SERVICE BULLETIN

NUMBER: DCI-BH206B-IBF-SB02
Date: 13 July 2021

SUBJECT: BACKSHELL FASTENER REPLACEMENT

Bell Helicopter - Model: 206B (STC SR09451RC) (SN 0001 & SUBSQ)

Figure 1 – Location of Backshell Screws Recommended for Replacement

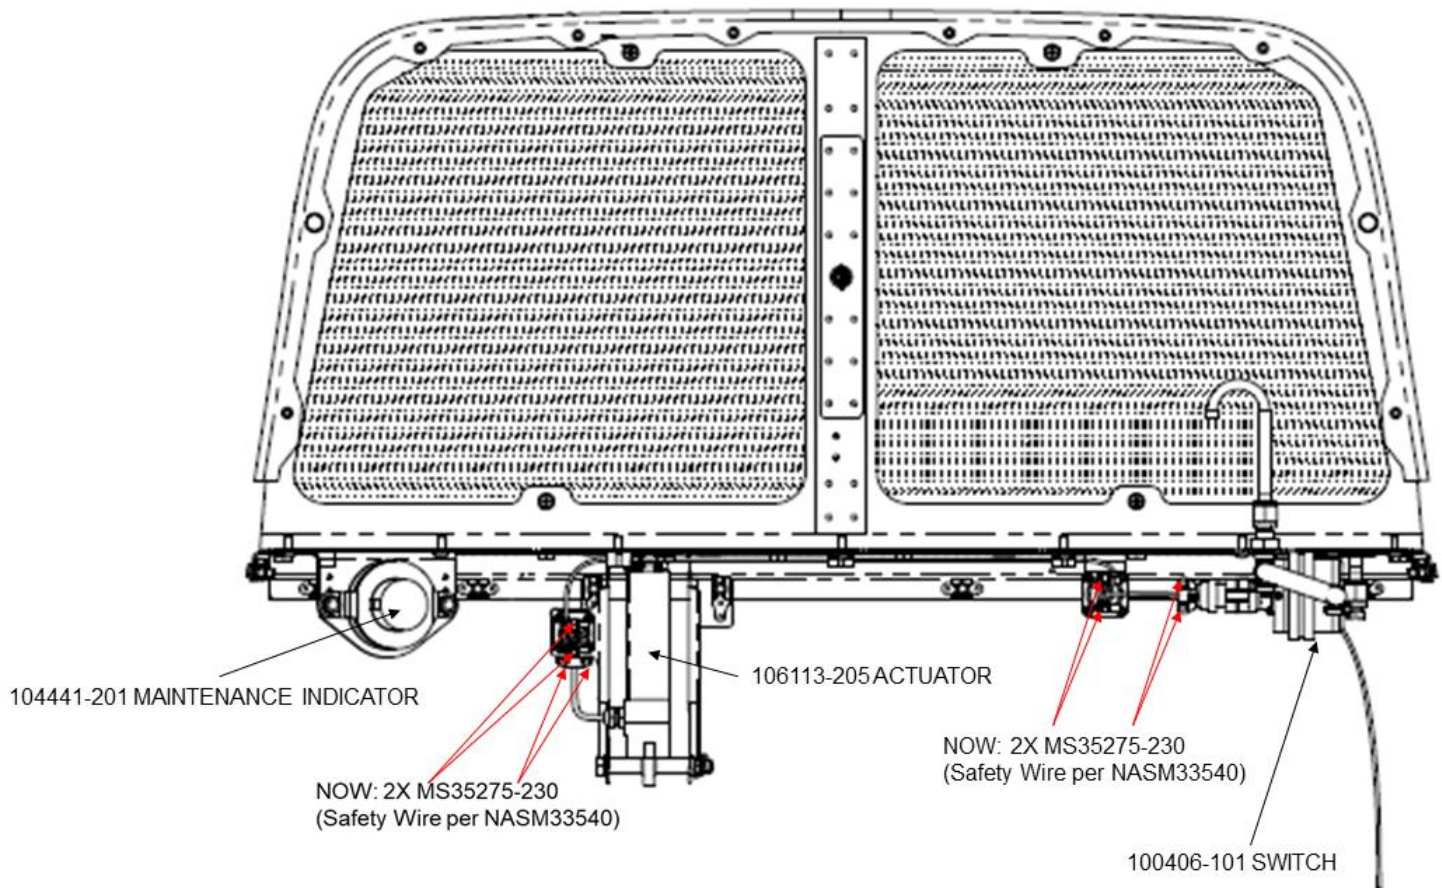
This is not a safety of flight issue, if operators follow Section 8.2.3 of the Instructions for Continued Airworthiness (ICA) and verify that Backshells are secure during regular maintenance intervals, then it is highly unlikely that the Backshell fasteners will come loose during flight. Nonetheless, Donaldson recommends a product improvement for all operators of the DCI Bell 206B IBF by replacing the existing fasteners on the Backshell of the 109401-101 Wire Harness connecting to the linear actuator & the Backshell of the linear actuator (106113-205) with MS35275-230 screws and to safety wire the screws per NASM33540. Location of these screws can be found depicted in Figure 1. Inspection requirements for the Backshells will remain the same unless otherwise directed by a newer revision of the ICA (Reference 1).

Operators are recommended to locally procure the replacement hardware as applicable. If local procurement is not available, operators can procure the screws from Donaldson's ecommerce site found in the Contact section.
